COUNCIL ASSESSMENT REPORT

SYDNEY CENTRAL CITY PLANNING PANEL

PANEL REFERENCE & DA NUMBER	PPSSCC-472 - DA 59/2024/JP
PROPOSAL	Demolition of Existing Structures and Construction of a Residential Flat Building Containing of 148 Units
ADDRESS	17-23 Fishburn Crescent Castle Hill 23-27 Chapman Avenue Castle Hill
APPLICANT	Archidrome Pty Ltd
OWNERS	Mr T Gavellas, Mrs D Gavellas, Mr C Efstathios, Miss A Gavellas, Mr C N Gavellas, Mrs S Peharda, Mr A Ghaffar, Ms D Ansari, Mr D Wyatt, Mrs F Wyatt, Mrs X Di, Mr Y Guo, Mr N Emanouel, Mrs H Emanouel and Ms L Lee, Ms M Lee
DA LODGEMENT DATE	14 July 2023
APPLICATION TYPE	Development Application
REGIONALLY SIGNIFICANT CRITERIA	Section 2.19 and Schedule 6 of SEPP Planning Systems 2021
CIV	\$62,648,550.00 (excluding GST)
CLAUSE 4.6 REQUESTS	The Hills LEP 2019 Clause 4.3 Height of Buildings R4 High Density Residential zone
KEY SEPP/LEP	The Hills LEP 2019
TOTAL & UNIQUE SUBMISSIONS KEY ISSUES IN SUBMISSIONS	Two submissions Land owners consent not provided for eastern lot indicated in concept sketches. Construction management of traffic, noise and dust.

Figure 1: Type C9 2 bedroom units with study highlighted in yellow.

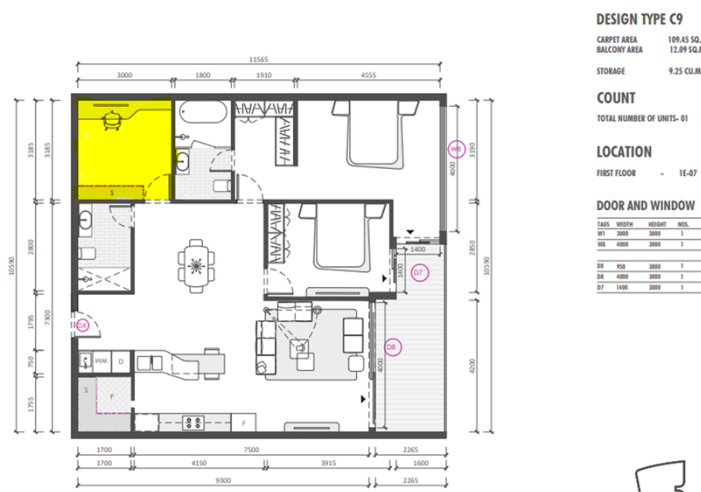
Whilst the unit mix described in the Applicant's Statement of Environmental Effects indicates compliance with the above provisions, this is not demonstrated in the plans or associated documentation. The submitted plans indicate that less than 40% of all 2 bedroom dwellings contained in the development will have a minimum internal floor area of 110m². It is noted that five units labelled as "Design Type C9 and C12" are 2 bedroom units containing study rooms which are capable of being used as bedrooms. These units have therefore been counted as 3 bedroom units.
